SN J1981A -01

S E R V I C E N O T E

J1981A VQT

Updated replacement of FXO Analog card for improved PESQ scores

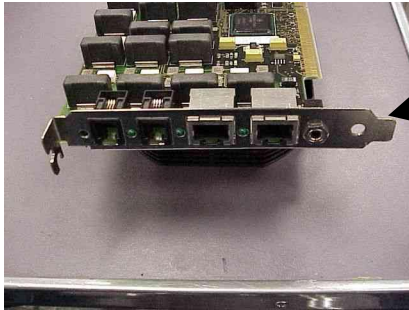
Adapting the Infineon ALIS FXO chipset for use in the E&M ports of the analog board results in extra circuit noise. This limits the maximum PESQ scores. Replacing this board with the modified assembly reduces the circuit noise and improves the possible PESQ scores when using the E&M ports

Replace the analog FXO E&M card with the latest version. This, along with downloading the VQT application Software Version 4.1.1 or later. When the “defective” analog card is removed the metal grounding tab **MUST** be swapped to the new assembly.

Move metal tab to
new assembly.
